Intersection ID: 4819	Main Street: CLIFF_CAMERON_DR	Cross Street: WILLIAM_FICKLEN_DR	Location:	NE
ADA ID: 091AA75D0E12	Ramp Type: Perp	Initial Pass/Fail: Fail	Overall Compliance: No	Severity Score: 10

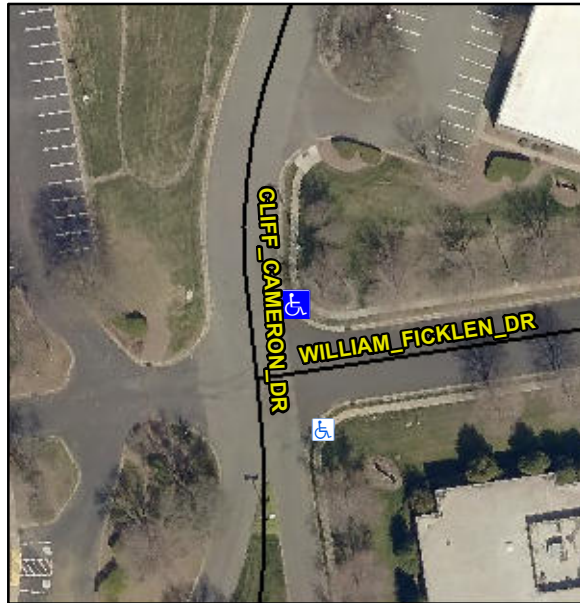
R304.5.1, R304.5.3

Compliance	Description	Data	Compliance	Description	Data
N/A	Ramp Length (in)	46.0	Yes	Ramp Slope (%)	7.8
No	Ramp Width (in)	46.0	No	Ramp XSlope (%)	4.7
N/A	Flare Type LT	N/A	N/A	Flare Type RT	N/A
N/A	Flare Slope LT (%)	N/A	N/A	Flare Slope RT (%)	N/A
N/A	Flare Traversable LT?	N/A	N/A	Flare Traversable RT?	N/A
N/A	Landing Length (in)	N/A	N/A	DWS Provided?	N/A
N/A	Landing Width (in)	N/A	N/A	DWS Contrast?	N/A
N/A	Landing Slope (%)	N/A	N/A	DWS Length (in)	N/A
N/A	Landing X Slope (%)	N/A	N/A	DWS Full Width?	N/A
N/A	Landing Curb? (Y/N)	N/A	N/A	DWS Offset (in)	N/A
N/A	Shared Landing?	N/A			
N/A	Gutter Ponding?	N/A	N/A	Gutter Slope (%)	N/A
N/A	Gutter Lip Ht (in)	N/A	N/A	Gutter X Slope (%)	N/A
N/A	Painted X Walk1?	No	N/A	Painted X Walk2?	N/A
	X Walk 1 Direction	To S		X Walk 2 Direction	N/A
N/A	X Walk 1 Width (in)	N/A	N/A	X Walk 2 Width (in)	N/A
	X Walk 1 Slope (%)	3.3		X Walk 2 Slope (%)	N/A
	X Walk 1 X Slope (%)	0.5		X Walk 2 X Slope (%)	N/A

Remove & Replace Entire Ramp.
